Quad Cities Nuclear Power Station, Units 1 and 2
Facility Operating License Nos. DPR-29 and DPR-30
NRC Docket Nos. 50-254 and 50-265

Subject: NRC Request for Additional Information

**Fire Protection Engineering Evaluation
Q-ECDS-00-165**

**GL 86-10/Appendix R Evaluation
Drywell Expansion Gap**

FIGURE E-2
TYPICAL MECHANICAL
PENETRATION ASSEMBLIES
(SHEET 2 OF 2)

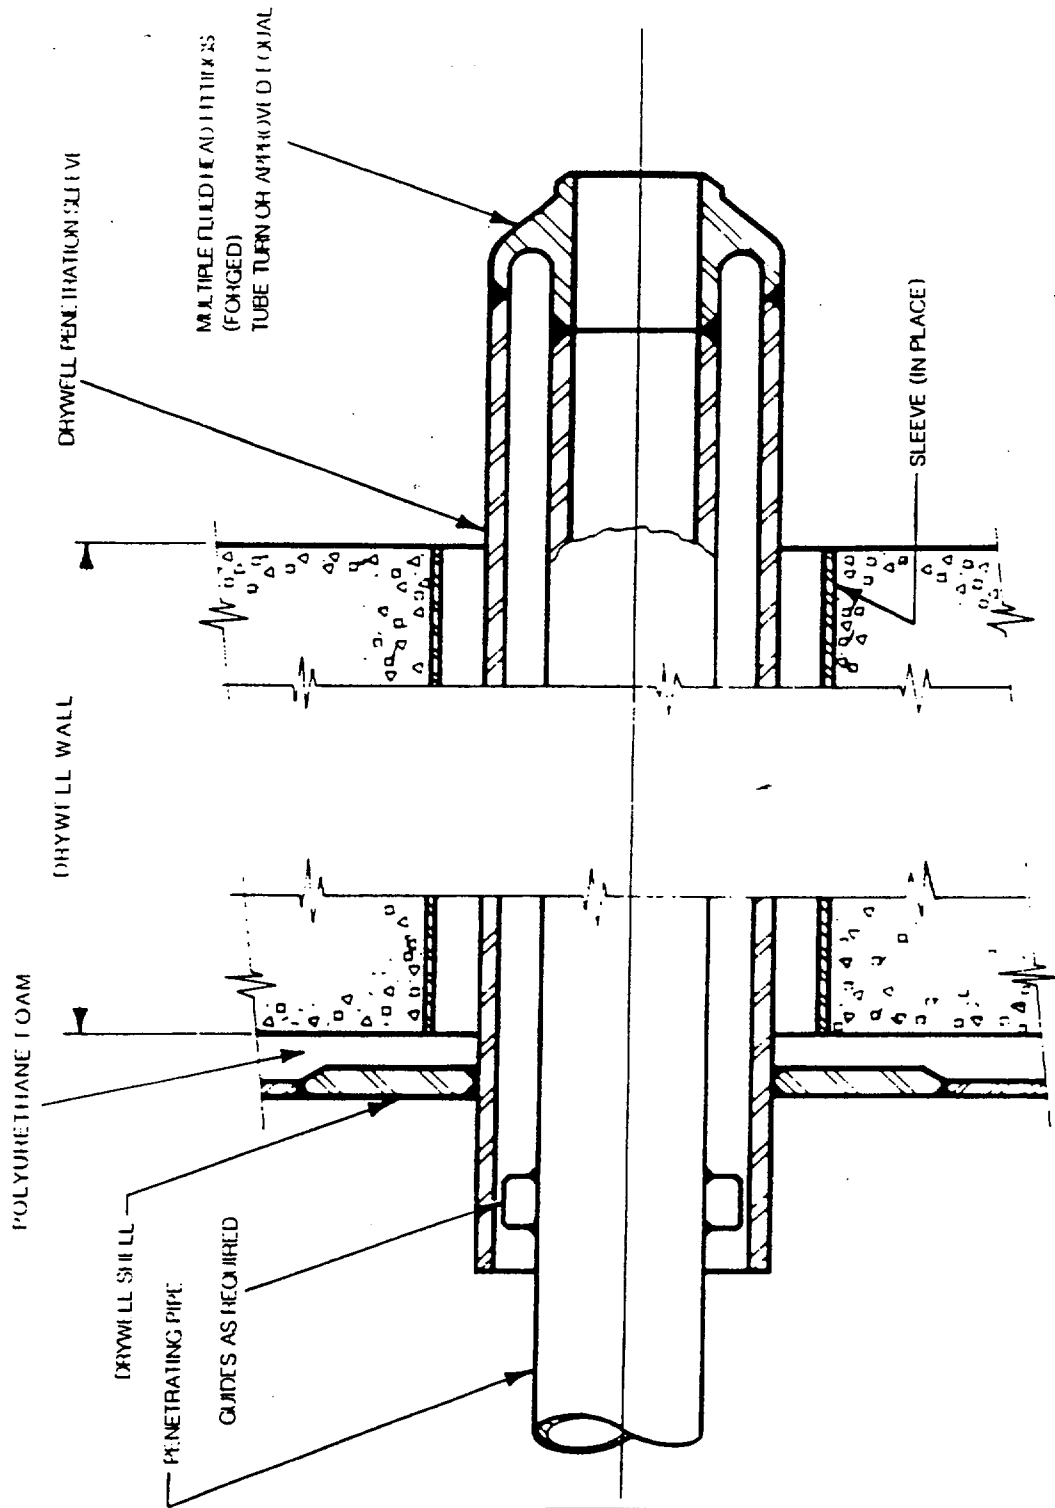
The location of the expansion gap and foam sheeting with respect to the penetrations is shown on attached Figures E-1 and E-2, sheets 1 and 2. These are the basic configurations for each of the mechanical and electrical containment penetrations. Based on these configurations, it is apparent that the foam sheeting material within the expansion gap is completely isolated from the penetration opening and from the penetrating objects. The separation is provided by steel sleeves and plating. Therefore, there is no direct contact or fire exposure to or from the foam sheeting. Furthermore, welded-end steel fittings, sleeves, or headerplates provide a complete airtight containment enclosure around the penetration openings.

FIGURE E-1

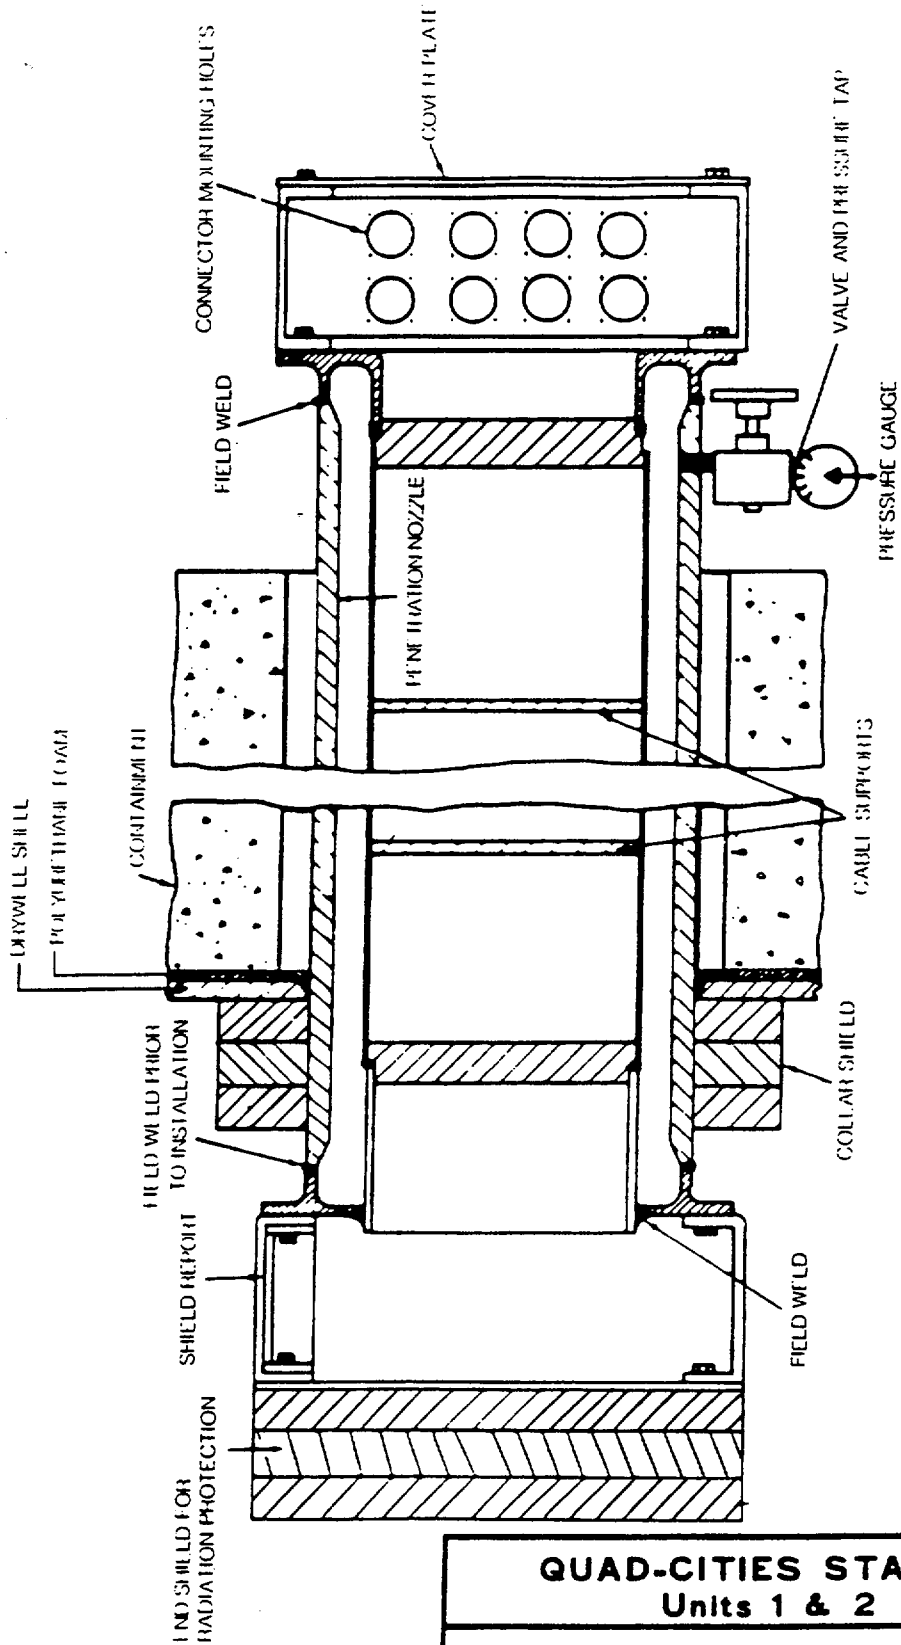
Electrical penetrations are functionally grouped into low voltage power and control cable penetration assemblies, high voltage power cable penetration assemblies, and shielded cable penetration assemblies. The electrical penetrations are pressurized/nitrogen inerted and have the same basic configuration shown in UFSAR Figure 3.8-39 (Reference 4.11). An assembly is inserted in the 12-inch schedule 80 penetration nozzles which are furnished as part of the
